SUBJECT: ISSUANCE OF AMENDMENT (TAC #66056)

NORTHEAST NUCLEAR ENERGY COMPANY
THE CONNECTICUT LIGHT AND POWER COMPANY
THE WESTERN MASSACHUSETTS ELECTRIC COMPANY
DOCKET NO. 50-336
MILLSTONE NUCLEAR POWER STATION, UNIT NO. 2
AMENDMENT TO FACILITY OPERATING LICENSE

Amendment No. 122
License No. DPR-65

SAFETY EVALUATION BY THE OFFICE OF NUCLEAR REACTOR REGULATION

Figure 3.2-1 Allowable Peak Linear Heat Rate vs Burnup

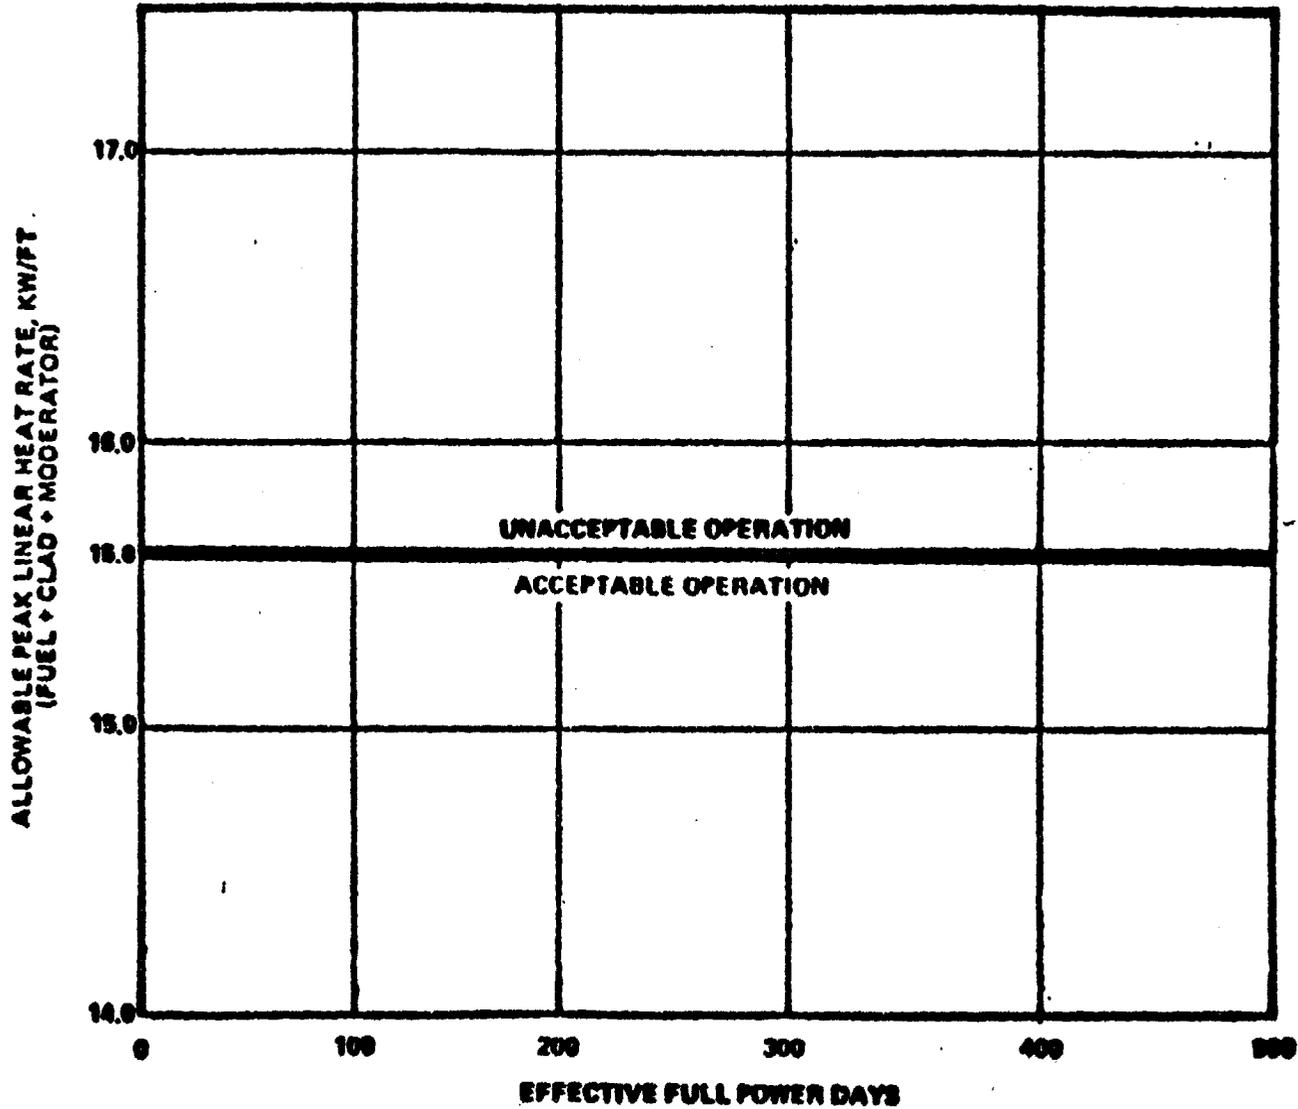
The change modifies the Technical Specifications (TS) as follows: (1) the maximum linear heat rate shown in TS Figure 3.2.1 would be reduced from 15.6 to 14.0 kw/ft, and a factor of 1.115 would be applied to the planar peaking for reactor operation during Cycle 8 beyond a core average burnup of 9500 MWD/MTU, and (2) the equations of TS Figure 3.2.-3b would be deleted.

The licensee has proposed to reduce the allowable a maximum linear heat rate (LHR) and total planar radial peaking factor (F_{xyT}) by 11.5% for extended operation, as reflected in proposed TS Figure 3.2.1, F_{xyT} Allowable Peak Linear Heat Rate vs. Burnup." These reductions allow the average LHR to remain unchanged while increasing restrictions on boundary conditions during extended operation. Using known sensitivities of the LHR that have been used in previous Millstone 2 operating cycles, the proposed maximum allowable values for LHR and F_{xyT} would compensate for the effect of extended operation on the bounding LOCA transients. These sensitivities were determined using NRC staff-approved, ECCS evaluation models. Additional conservativeness is assumed in the evaluation. Steam generator tube plugging is assumed at 23.4% when the actual value is about 17.6%. Beginning-of-life fuel temperatures were used in the evaluation without taking credit for the lower end-of-life temperatures. Therefore, the results of the evaluation ensure a PCT, local cladding oxidation rate, and whole-core hydrogen generation level that remain within the values for Cycle 8, which satisfy the requirement of 10 CFR 50.46.

* A limit of 14.0 KW/FT is required for Cycle 8 only whenever the core average burnup is \geq 9500 MWD/MTU.

A reduced linear heat rate limit of 14.0 kW/ft for Cycle 8 operation beyond a core average burn-up of 9500 MWD/MTU ensures that the 2200°F peak fuel cladding temperature limit will not be exceeded in the event of a LOCA. The value of 9500 MWD/MTU is the predicted end-of-cycle for Cycle 8. Operation beyond the predicted end-of-cycle may require reductions in the reactor coolant temperatures which can increase the calculated peak clad temperatures. The reduction in the linear heat rate limit will more than compensate for the effect of the reduction in the reactor coolant temperatures on the LOCA analysis.

FIGURE 3.2-3b Total Radial Peaking Factor vs. Allowable Fraction of RATED THERMAL POWER

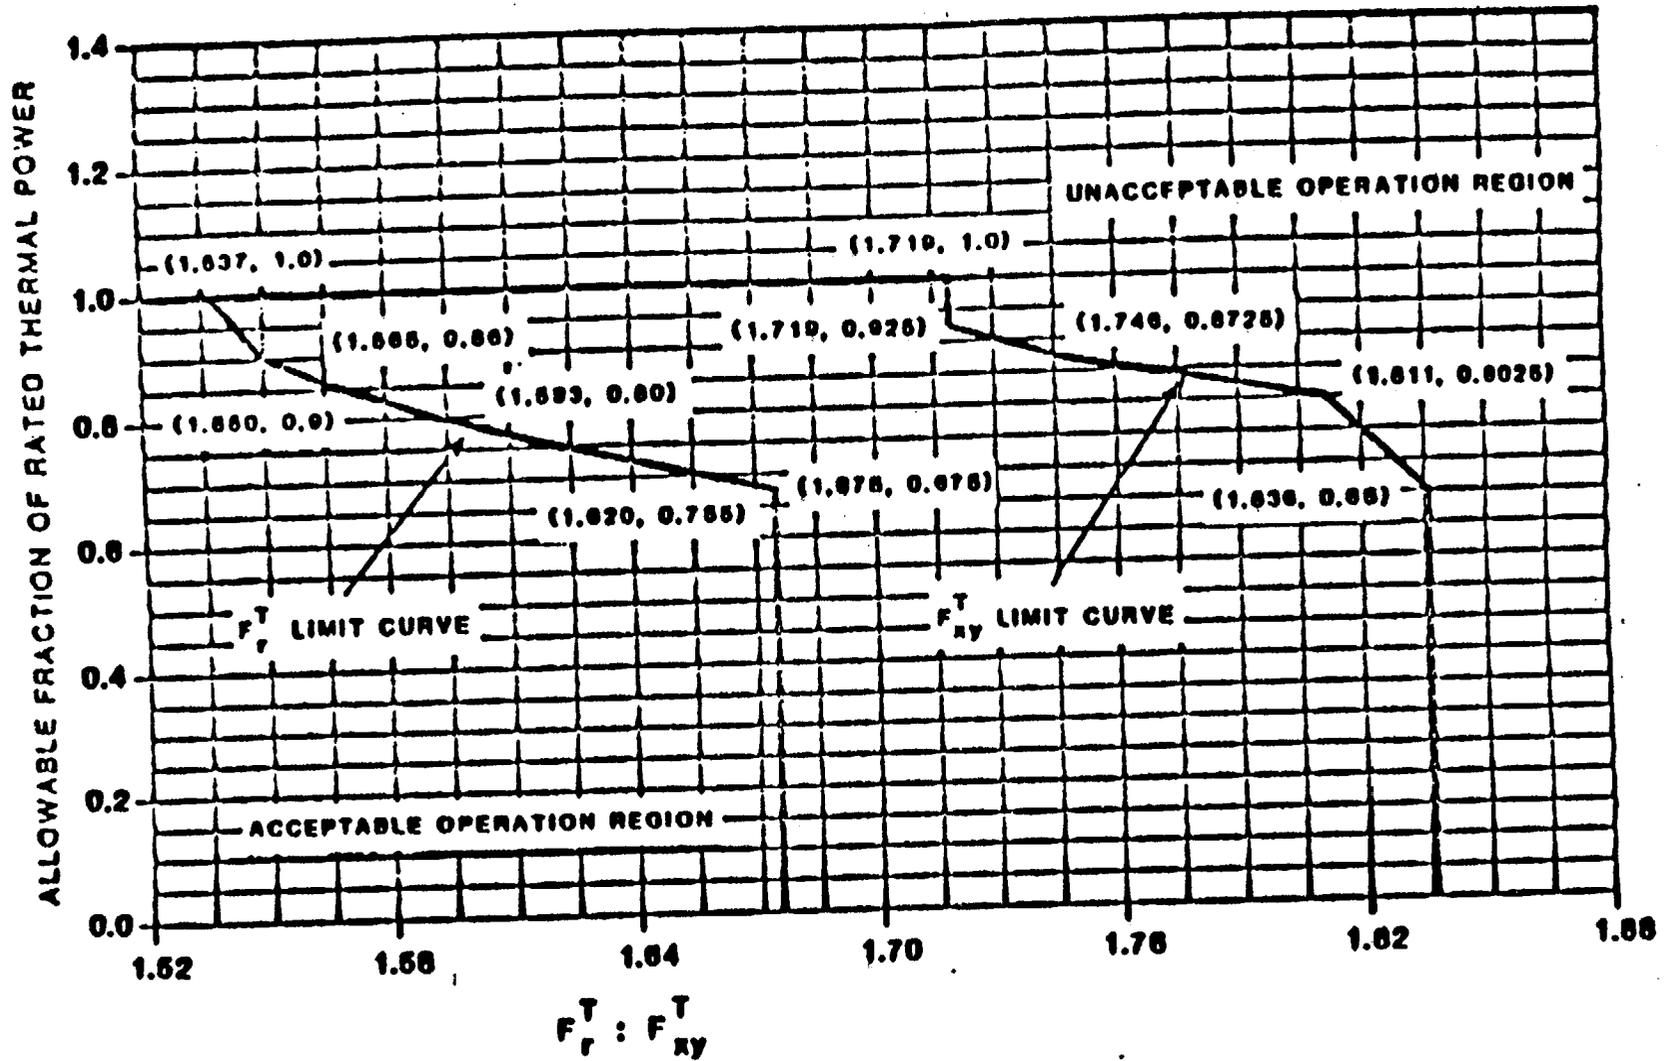
The final change to the TS addressed herein involves the proposed deletion of the equations for total planer and integrated radial peaking factors from TS Figure 3.2-3b; these equations already appear in TS 3.2.2.1 and 3.2.3, respectively. The proposed deletion of the subject equation would have no effect on the TS other than to delete an unnecessary repetition of the equations. Accordingly, the proposed deletion of the equations in TS Figure 3.2-3b is acceptable.
